Our Ref: TRW: R.B20133.007.00.West Culburra Review.docx

6 March 2014

RE: PROC-1000395 – WEST CULBURRA WATER CYCLE MANAGEMENT REVIEW

Figure 1 SPEL Storm Ceptor Class 1 (SPELenvironmental.com.au)

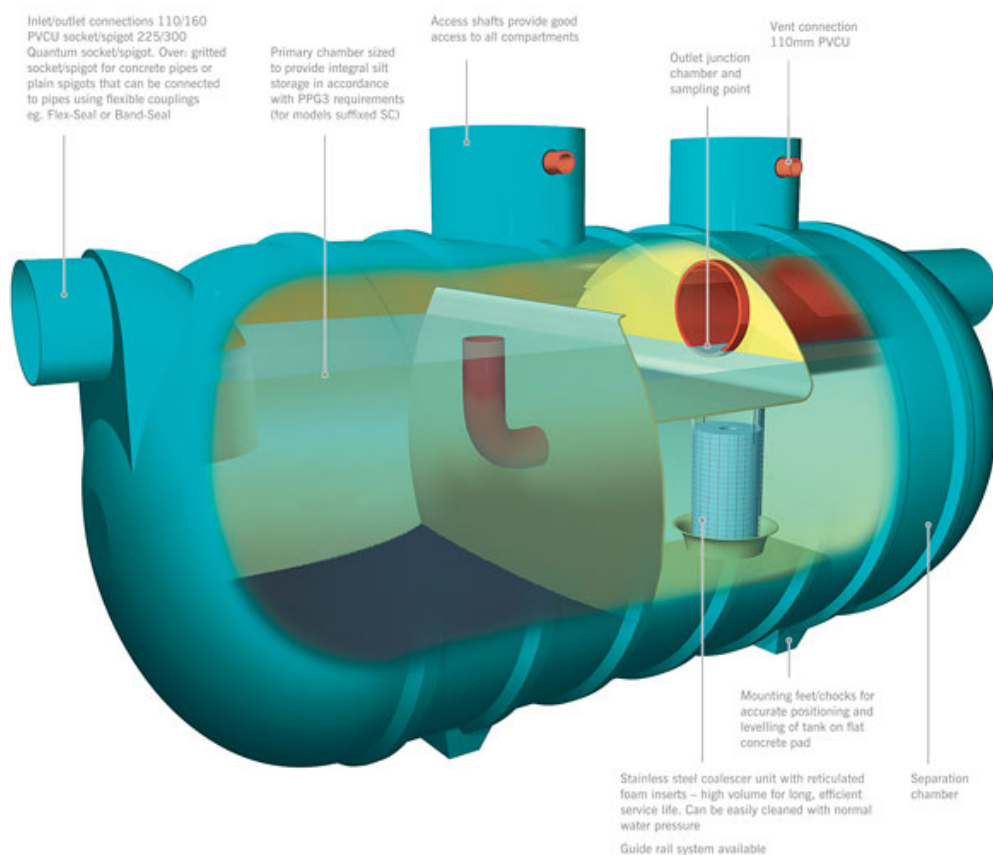
- b) Within the Martens report and associated MUSIC model, the proponent is relying upon the operation of proprietary devices to assist in achieving the stormwater quality targets for the site. In this case, numerous SPEL Storm Ceptor Class 1 units have been proposed. An indicative image of the layout of these devices is shown below.

Within the MUSIC model, pollutant load reduction rates of 97% for Total Suspended Solids and 30% for Nitrogen and Phosphorus have been used, however no documentary evidence has been provided to show that these devices can achieve such high reductions. The draft NSW MUSIC Modelling Guidelines to which the report author refers to states that “This data should be derived from an independent, published source (i.e. not simply based on proprietor supplied data).” It would appear that they have relied upon the proprietor supplied data in this case. I note also that the unit proposed is designed as an oil and grit/sediment separator, not a gross pollutant trap. Again the draft NSW MUSIC Modelling Guidelines state “If a proprietary device is noted as being an oil and grit/sediment separator, no gross pollutant removal is to be attributed to the device, nor should it be used for this purpose.”

As such, the pollutant removal potential of these proposed devices is likely to be significantly less than that modelled within MUSIC and given that they are not appropriate for the locality

proposed, would likely represent a significant and on-going cost burden to the local council if they were a contributed asset. If maintenance of these devices is also not maintained, they have a strong potential to actually release contaminants to downstream waterways rather than continue to reduce them.

Recommendation 2: The proponent considers the use of other treatment measures than the proposed SPEL Storm Ceptor units. In particular, the use of surface treatment systems such as vegetated swales would offer considerable benefit in reducing both sediment and nutrients into the downstream bioretention basins and would also trap any gross pollutants on their surface. While not ideal from a gross pollutant perspective, the loads of gross pollutants post-development is unlikely to be significant and therefore such treatment systems are anticipated to be acceptable.

Figure 2 Revised MUSIC Model Spreadsheet

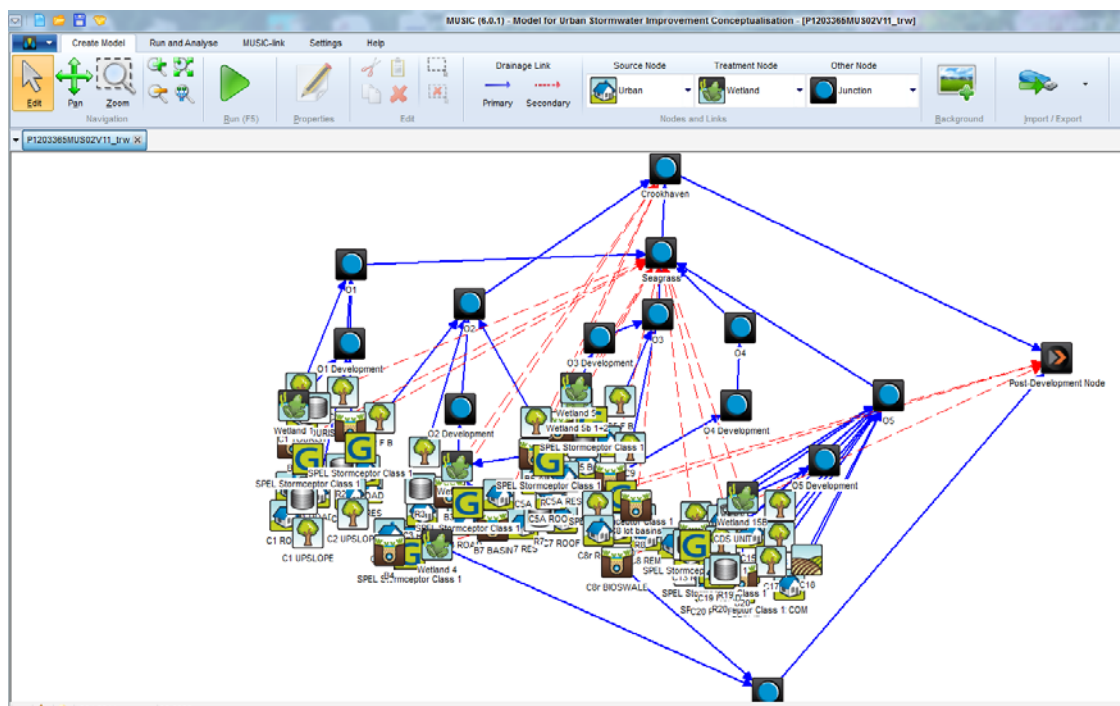
- f) The MUSIC model of the developed site assumes that there will be 3.6 mm/hr of seepage out of each of the treatment measures however there are several issues associated with this. Firstly,

such seepage rates were not used in the pre-development model so that a direct comparison with the runoff and pollutant loads cannot be made. Secondly, the infiltration rate assumed is not consistent with assessments of infiltration in the groundwater modelling section which identify a rate of <1mm/hr as representative of the soils on site. Thirdly, and most importantly, the model has been set up to assume that any infiltrated water effectively “disappears” from the site and does not reach the receiving environment. Given the proximity of the site to the Crookhaven estuary, such an assumption is not likely. A revised MUSIC model was developed where all infiltrated water lost through the seepage loss was directed to the catchment outlet using the “split-flow” functionality of MUSIC version 5.1.16 (and later versions). A screenshot is shown below. The red dashed lines represent the infiltration from the treatment measures.

As can be seen, with the seepage losses accounted for, the development is predicted to significantly increase the loads of nitrogen and phosphorus into the Crookhaven estuary and Lake Wollumboula with the proposed management measures, with a significant increase in flows

Recommendation 6: The proposed treatment train as modelled in MUSIC is not sufficient to protect the Crookhaven estuary, SEPP14 wetlands and Lake Wollumboula. The use of seepage losses in the model and the assumption that the infiltrated water “disappears” is not valid for the locality. The proponent should therefore significantly revise both the treatment train and the way it is modelled in order to demonstrate compliance with a Neutral or Beneficial Effect on the relevant receiving waters.
